**FINAL ADDENDUM
TO THE DRAFT EIR**

**KAISER PERMANENTE
MEDICAL OFFICE BUILDING
Environmental Impact Report**

February 8, 1991
ER-88-45
SCH# 90030072

Prepared for:
City of Oakland
City Planning Department

FIGURE A
ALTERNATIVE G-2
HOWE STREET ELEVATION

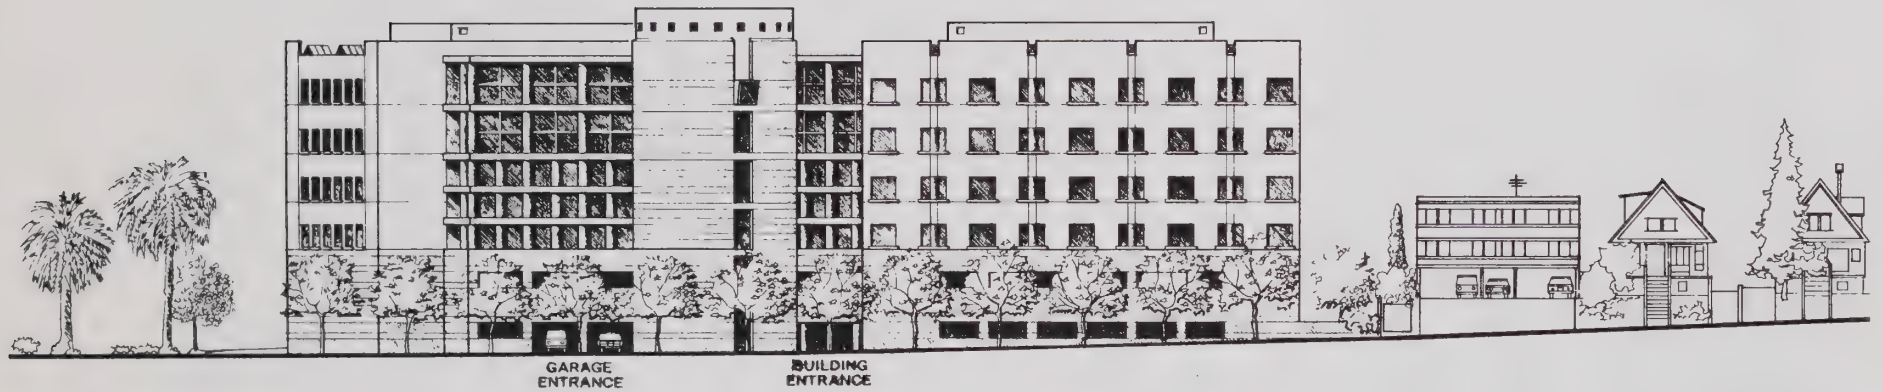
Comments 2, 17, 51, 71, 75, 81, 124, 141, 151, 161 and 297: Parking must be provided in the new building. Kaiser should provide 125 spaces or 475 spaces of free parking on-site.

Response: Insert the following as new alternatives to the proposed project, beginning on page 242 of the Draft EIR, at the end of DEIR Section XI Alternatives.

This alternative variant would consist of two parking levels below the proposed basement level of the medical uses area; this arrangement would be necessitated by the Magnetic Resonance Imager, Ultrasound and Catscan equipment situated within the basement level in response to requirements for shielding of operational radiation emissions and tunnel connection to the existing Hospital tower. The entrance and exits for the two parking levels would be at the site frontage on Howe Street. The above-grade building envelope of this alternative variant would be identical to that of the proposed project. This alternative variant would require excavation to a depth of about 30 feet below ground level at the Howe Street site boundary. Pile driving for foundation supports would also be required.

This alternative would result in certain impacts of greater magnitude than those of the proposed project. Subsurface parking levels would require excavation to ground water levels, requiring dewatering at the site during construction and likely throughout the lifetime of the project. Construction-generated noise would be

greater under this alternative, because pile driving would be required for building foundations under this alternative. Operational noise effects of this alternative would also be greater, because noise generated by dewatering pumps at the site and by ventilation equipment for the subsurface parking levels would increase noise generated by operation of this alternative variant compared to that generated by project operation. Construction air quality effects would be greater under this alternative, as a result of suspended particulate release resulting from subsurface excavation.

The project sponsors have rejected this alternative variant because construction costs would total about \$195 per gross square foot of building area, compared to construction costs of about \$140 per square foot with the project building; the higher alternative variant costs would be incurred by developing full radiation shielding around the MRI unit (including floor support), and the required subsurface pilings and foundation support. Kaiser considers a maximum new building cost of \$140 per square foot to be the maximum expenditure for cost-effective building./1/

This alternative variant would consist of two parking levels above grade, above the proposed basement level of medical use (see Figure A). The entrance and exit of the first parking level above grade would be from Howe Street, and the entrance and exit of the second level above grade would be from the site frontage at 38th Street and Cerrito Avenue. The basement level containing medical uses would be necessitated by the Magnetic Resonance Imager, Ultrasound and Catscan equipment requirements for shielding of operational radiation emissions and tunnel connection to the existing Hospital tower. The entrance and exits would be separated for the two parking levels because internal ramps would not allow provision of up to 75 spaces per floor. This alternative variant would be about 30 feet taller above ground than would the proposed project. Pile driving would be required for construction.
